ADDENDUM NO. 2

DPW Project #2023256

April 30, 2024

**DPW/UI – Ag Science Building HVAC Phase Two
University of Idaho
Moscow, Idaho**

SHEET
M3.52B

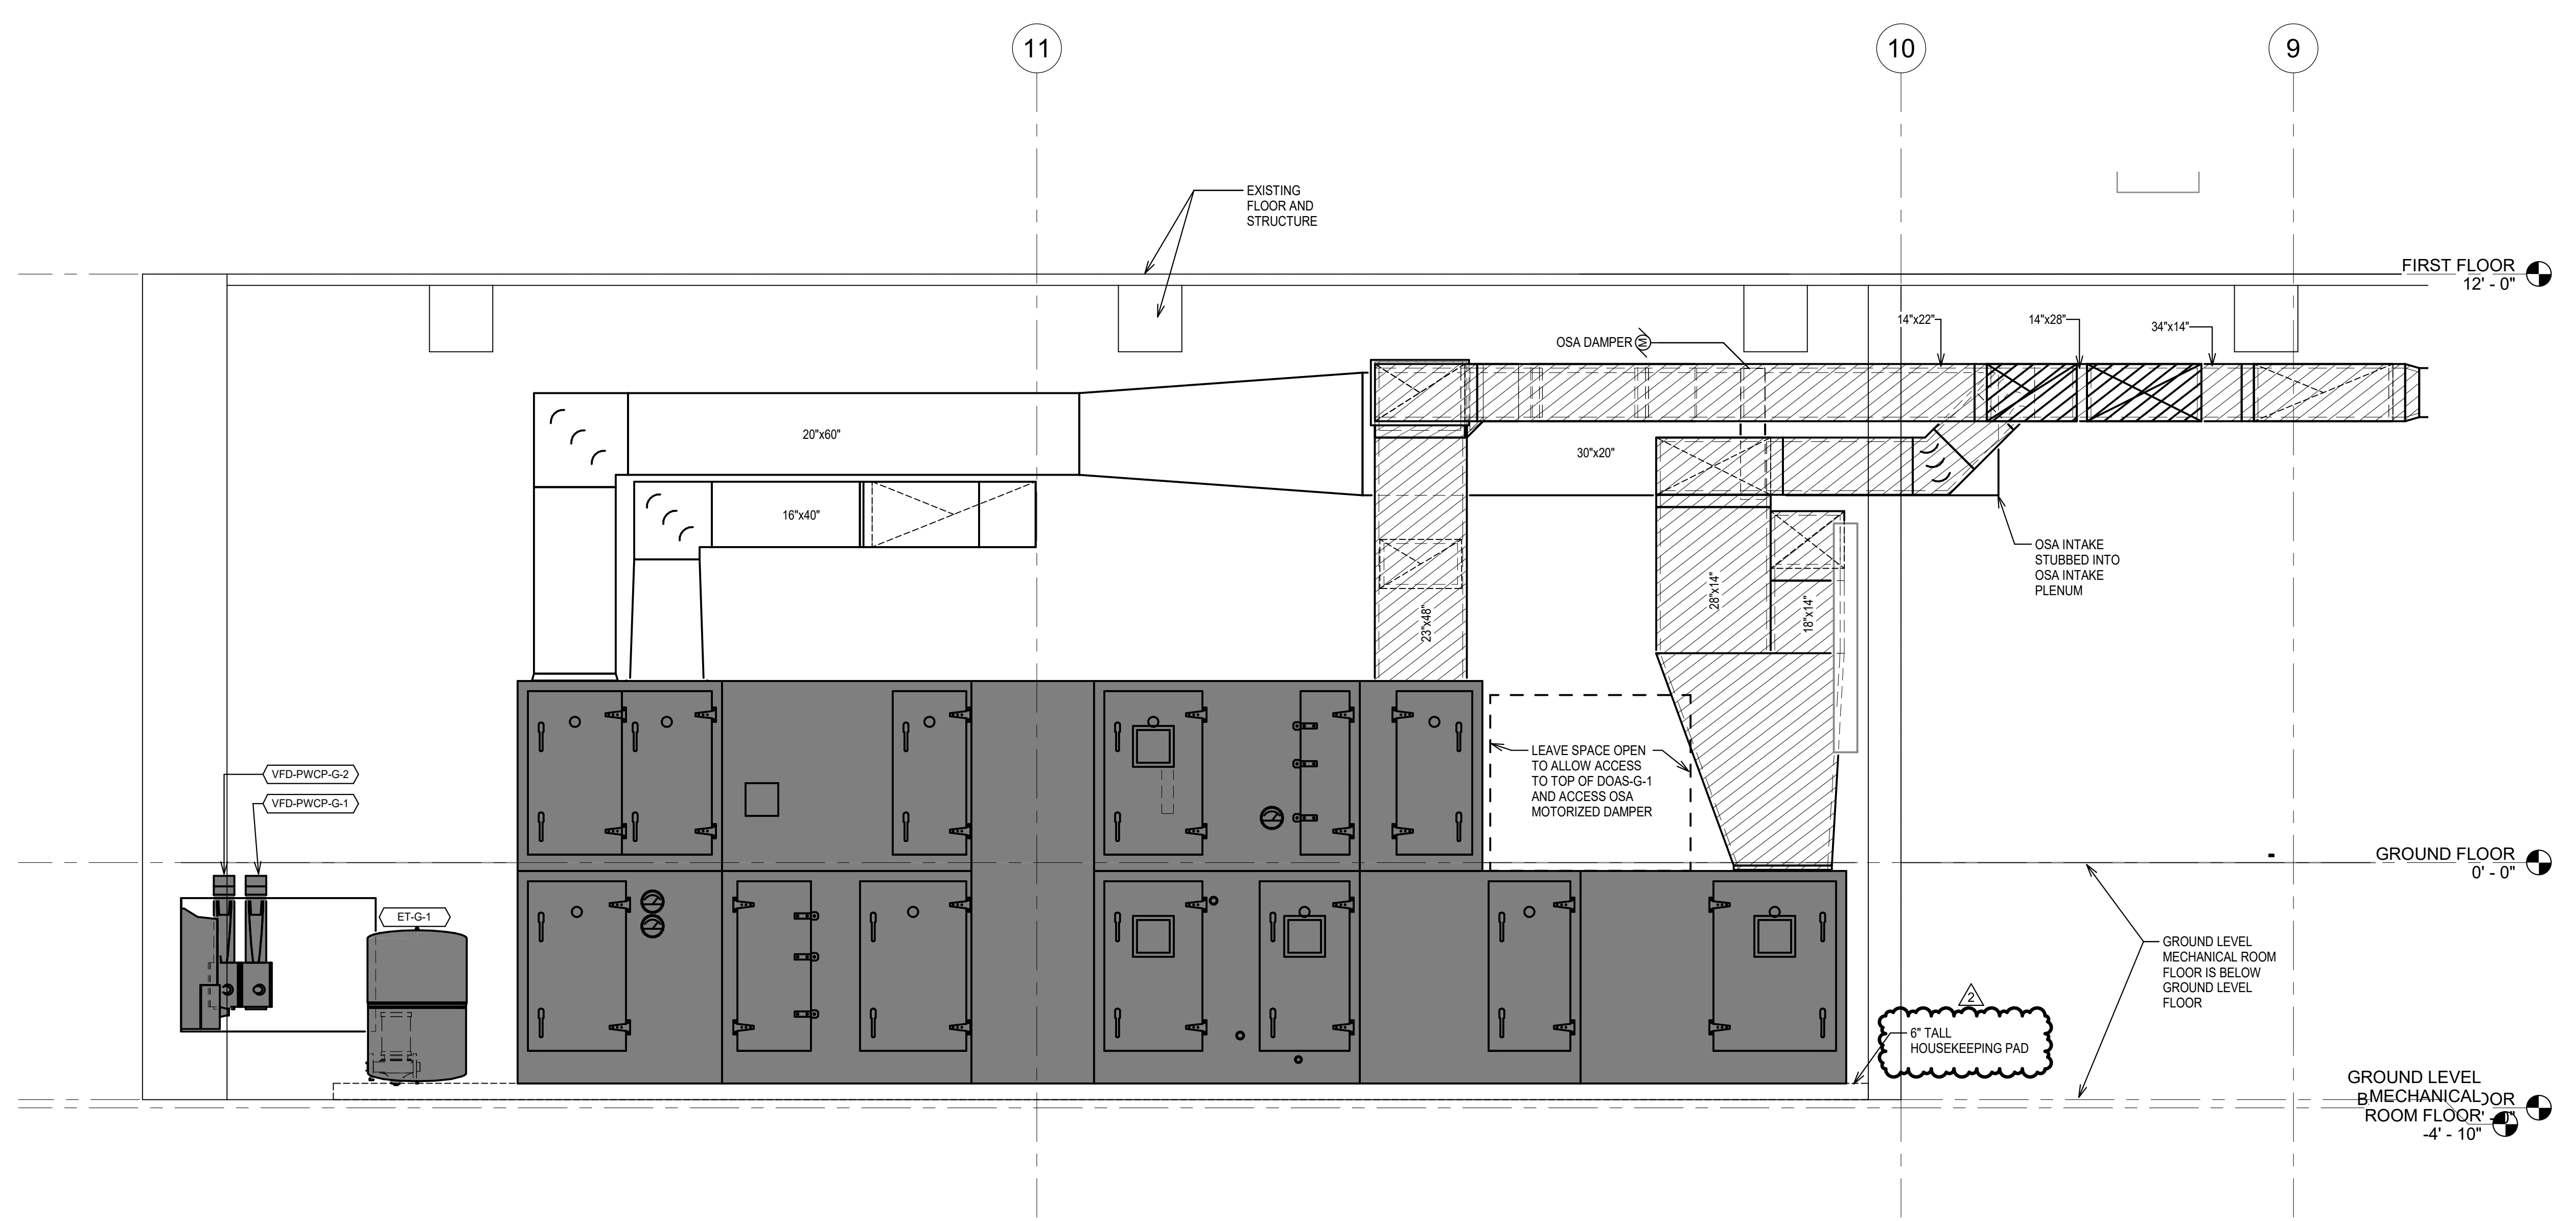
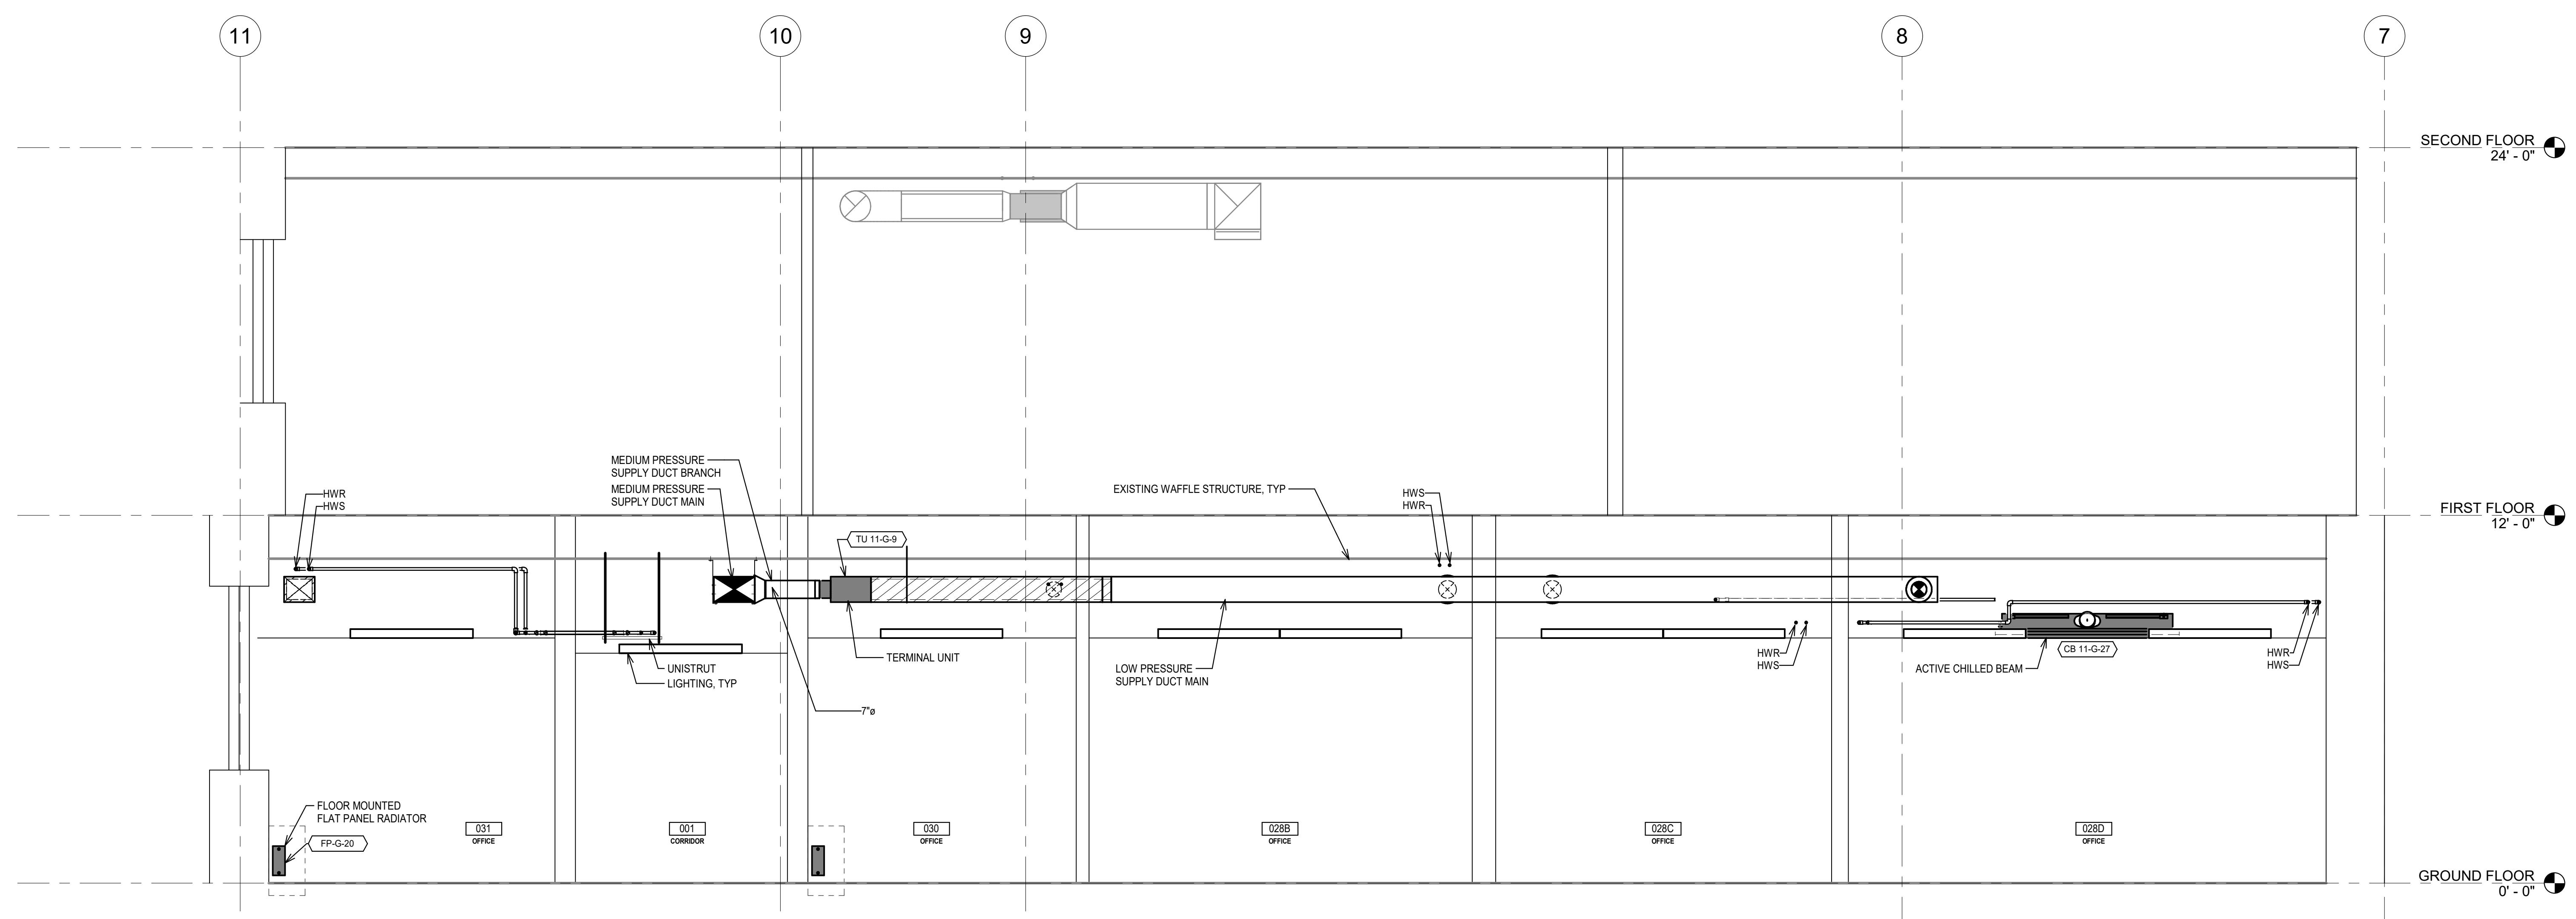
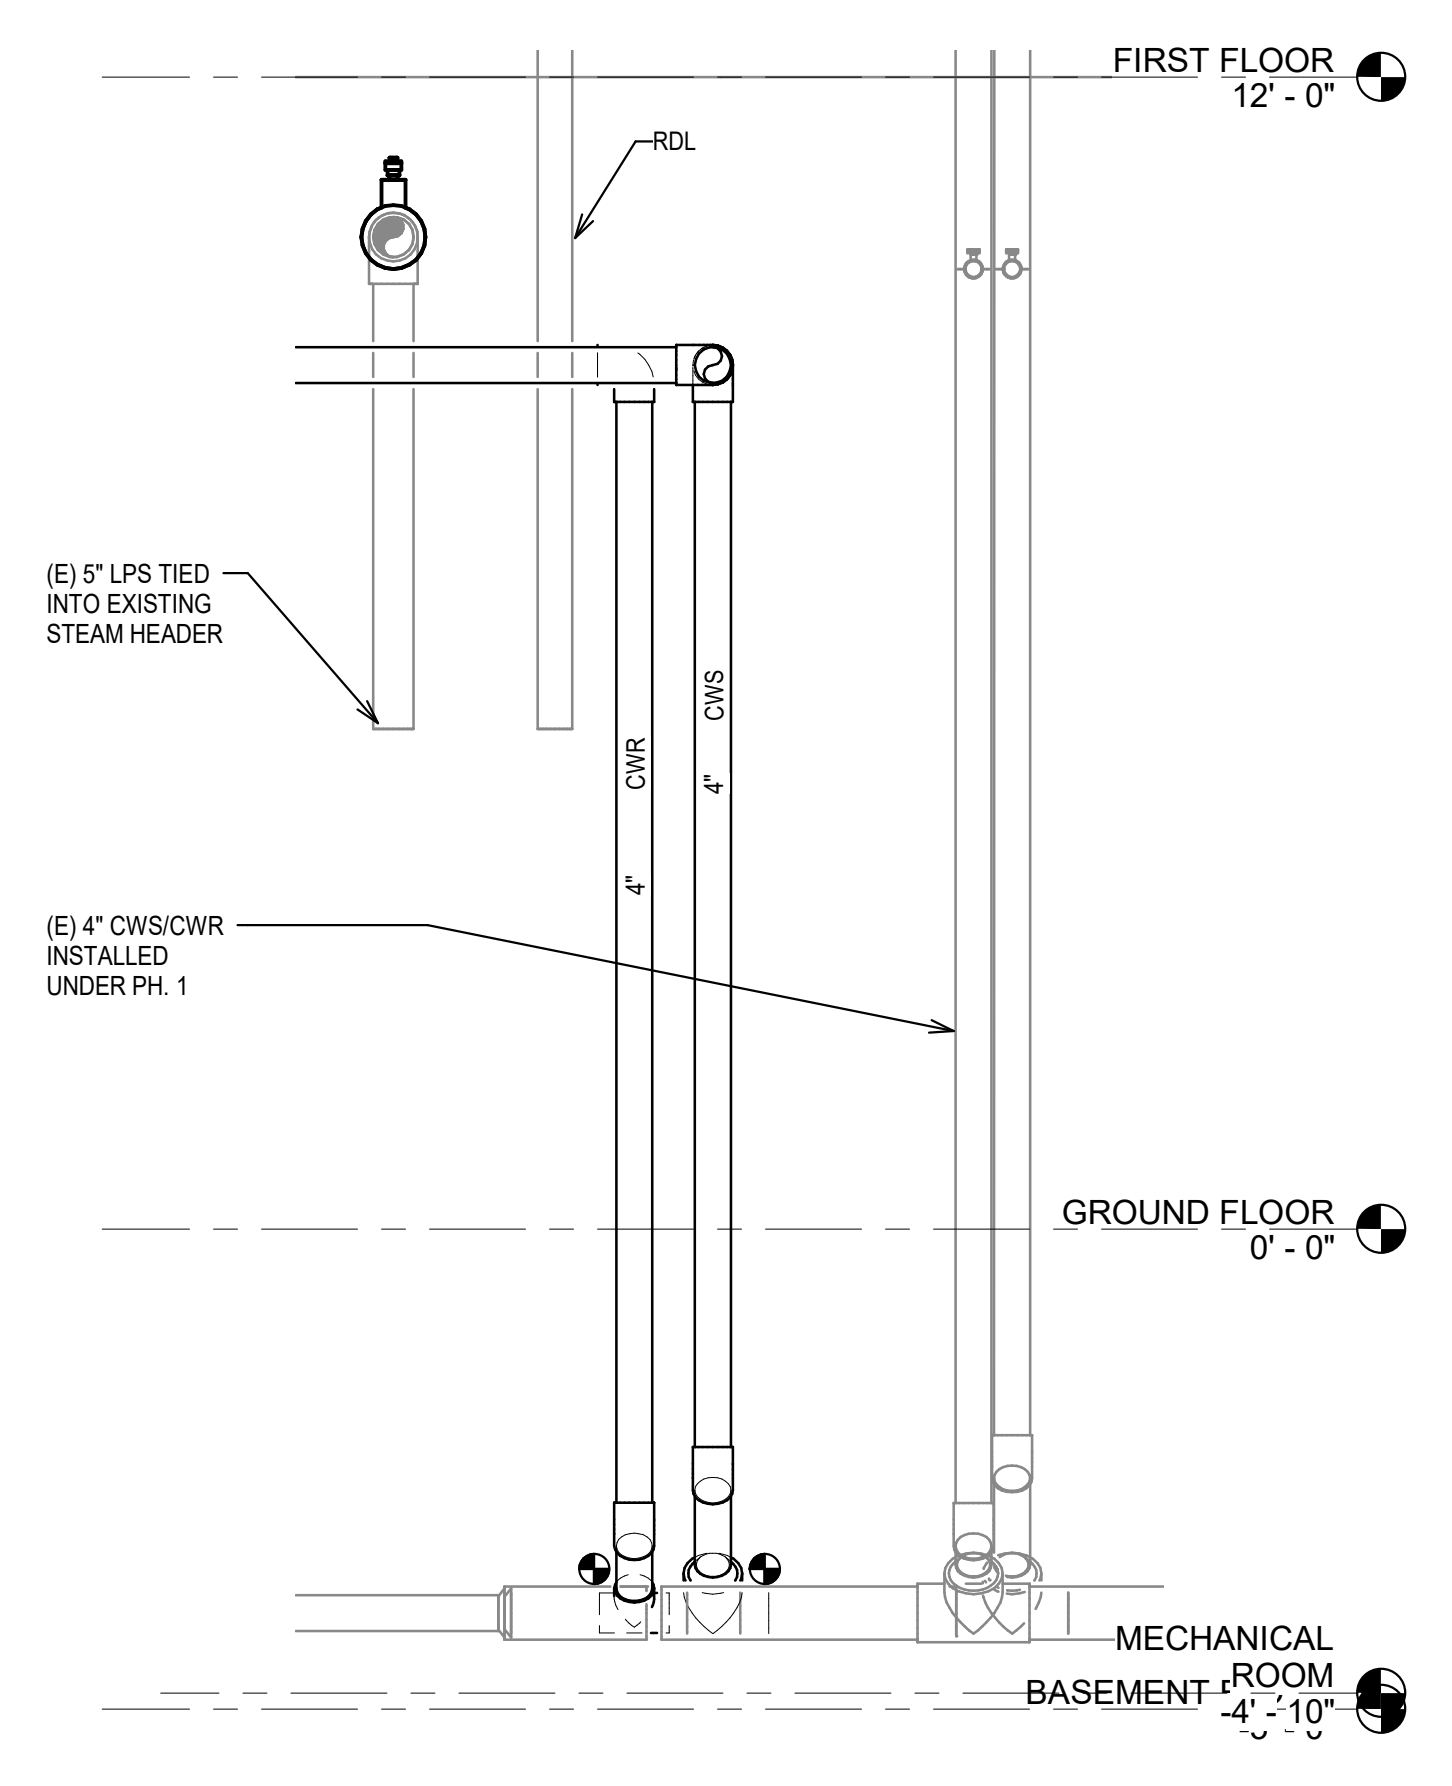
- 2.44 M3.52B - SECOND FLOOR AREA B - HYDRONICS**
REVISION: See attached drawing for revised piping routing and terminal unit placement for coordination.
